AGENDA
Cascade Charter Township Planning Commission
Monday, May 15, 2017
7:00 pm
Cascade Library Wisner Center
2870 Jacksmith Ave. SE

STAFF REPORT: Case # 17-3379
REPORT DATE: May 9, 2017
PREPARED FOR: Cascade Charter Township Planning Commission
MEETING DATE: May 15, 2017
PREPARED BY: Steve Peterson, Community Development Director

To: Cascade Charter Township Planning Commission
From: Steve Peterson, Community Development Director
Subject: Case 16-3348 Edward Rose - Meadowbrooke PUD Amendment
Meeting date: May 15, 2017

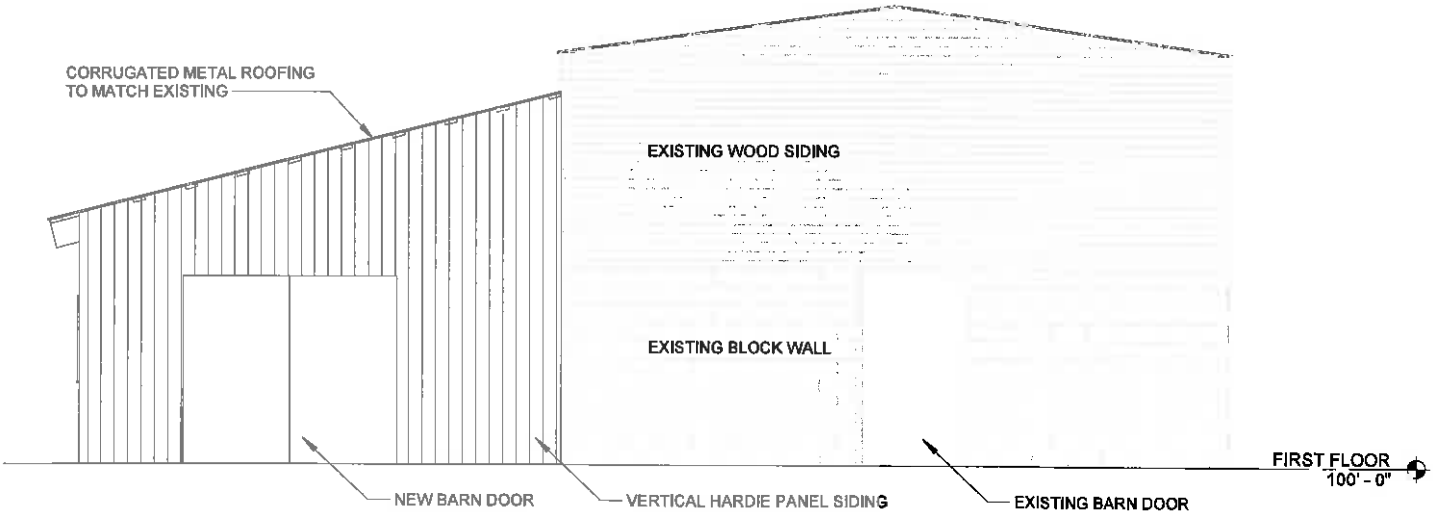
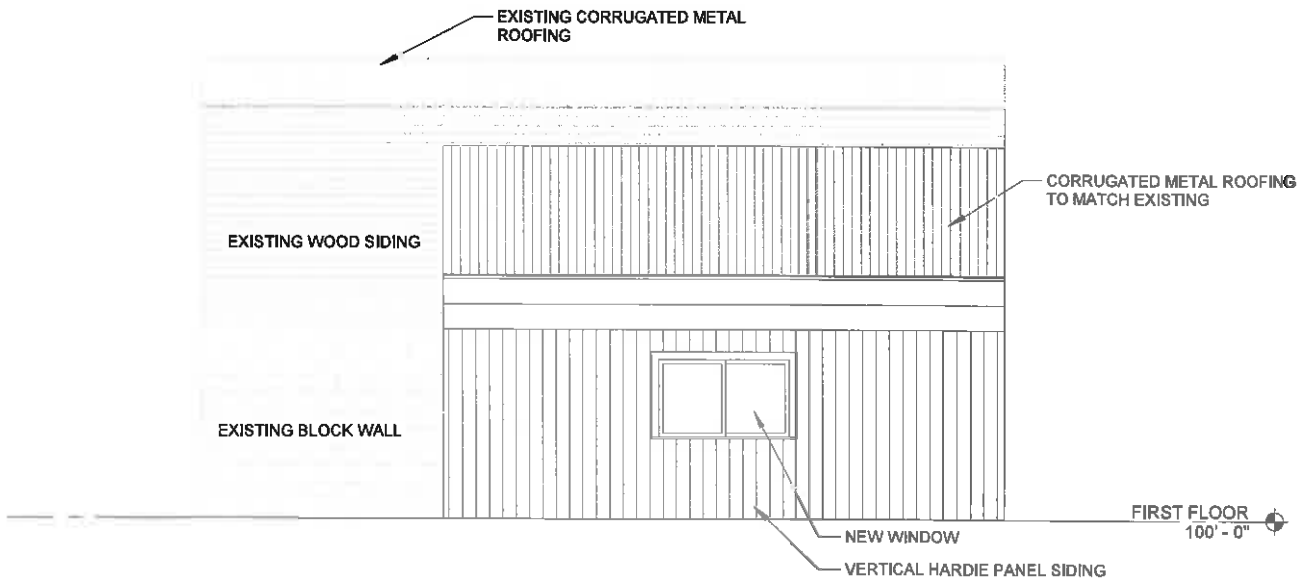
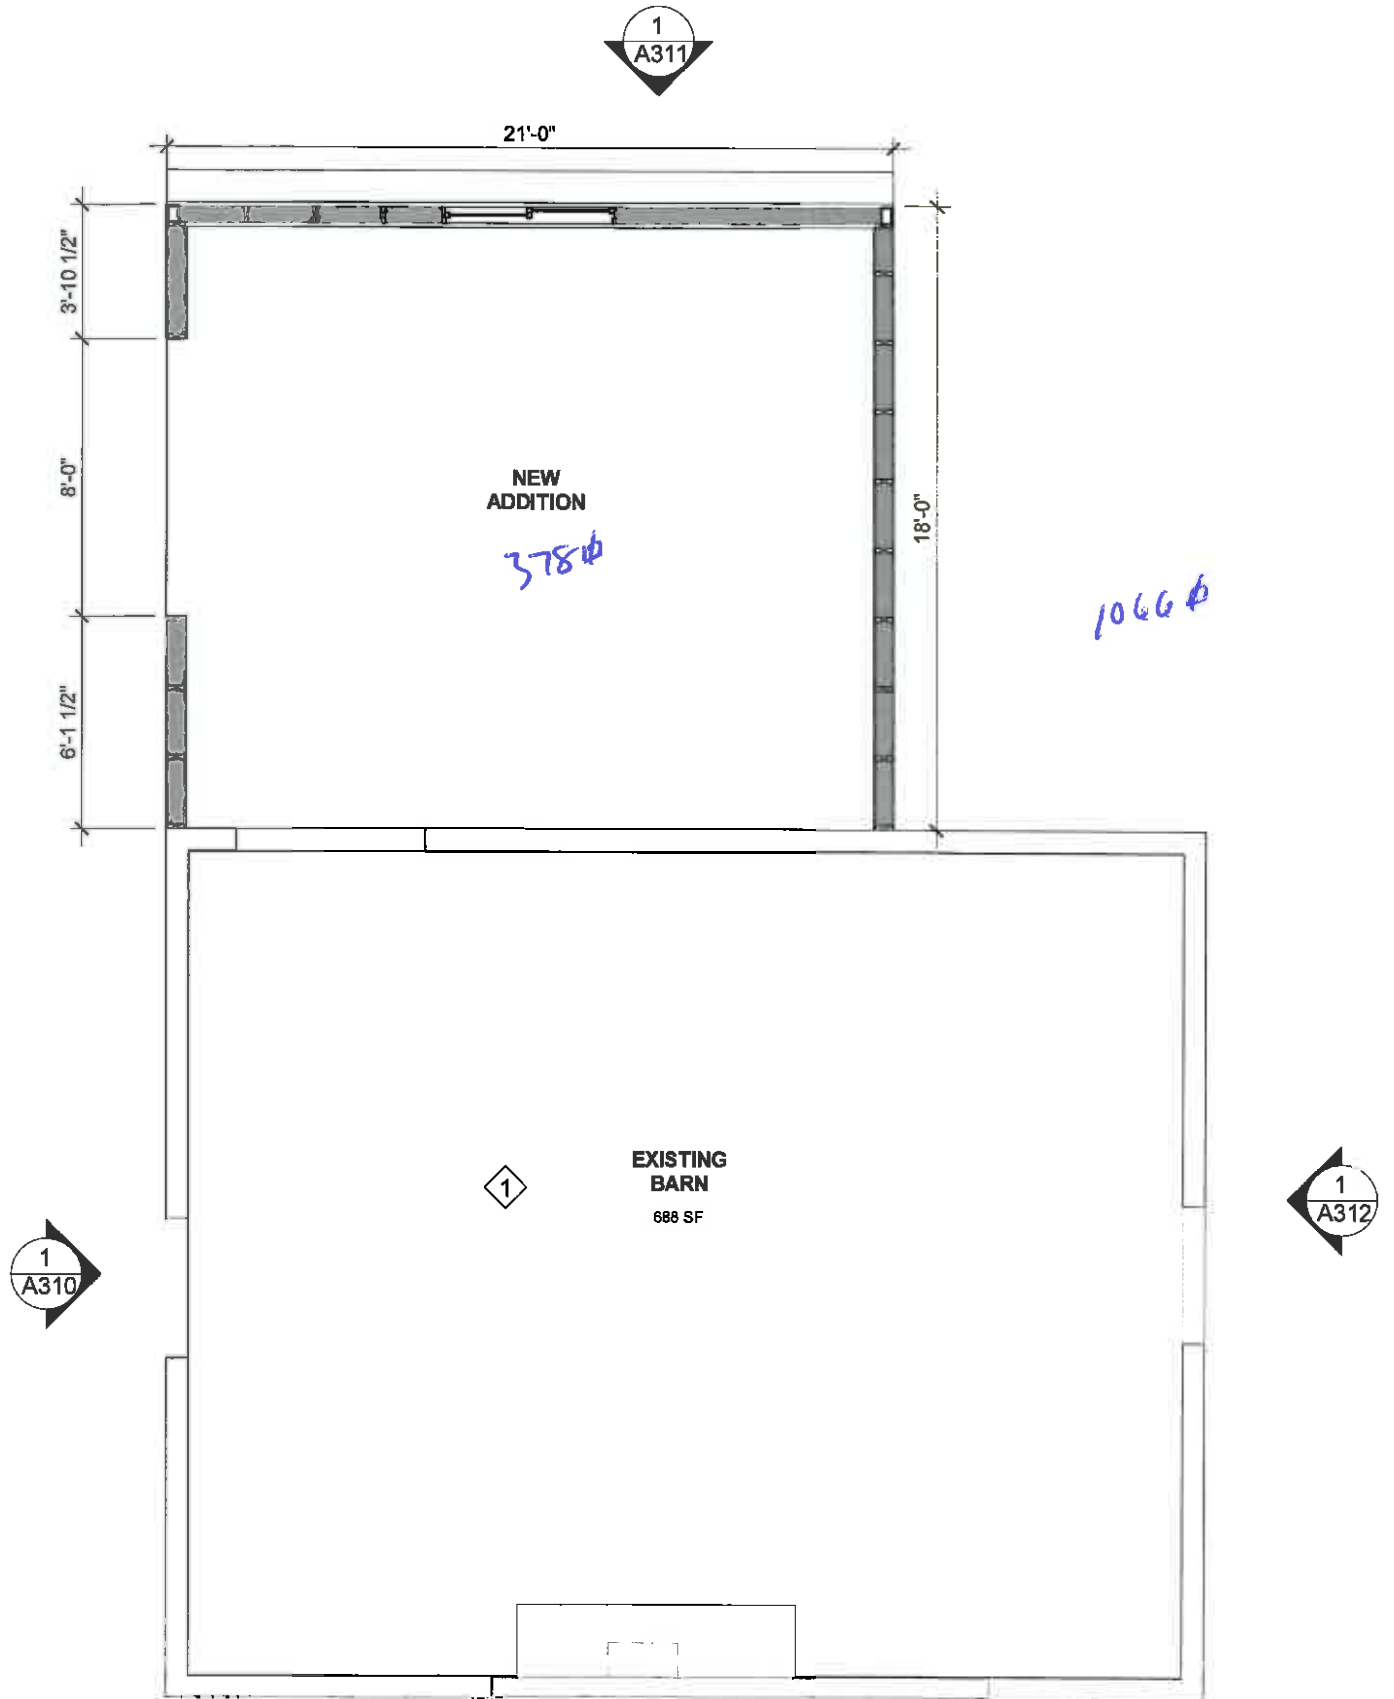
1. The applicant is requesting permission to construct a 18x21 addition to the existing accessory building. The existing accessory is about 688 sq ft. the addition would bring the total size to 1,066 sq ft. Now that the building would be over 832 sq ft it requires the special use permit.

2. The building is about 40 feet of the side (north) property line and is about 16 feet tall. This meets our minimum setback requirements.
3. They have indicated that they want the building for personal storage of lawn tractor, trailer and wood working.

4. With less than 3 acres the property would only be allowed this one accessory building. They have a second building on the property that they plan to remove as a result of this project.

5. The materials for the building will be the same as the existing. This is a metal roof with wood siding.
6. Any outdoor lighting will have to meet our standards, requiring it to be shielded and downcast or at a level that is exempted.

I would recommend that you approve the request to construct the addition to the existing accessory building;

1. The building is not used for living space or to run a business.
2. Any outdoor lighting meets our regulations.
3. Remove the small shed within 30 days of completing the addition
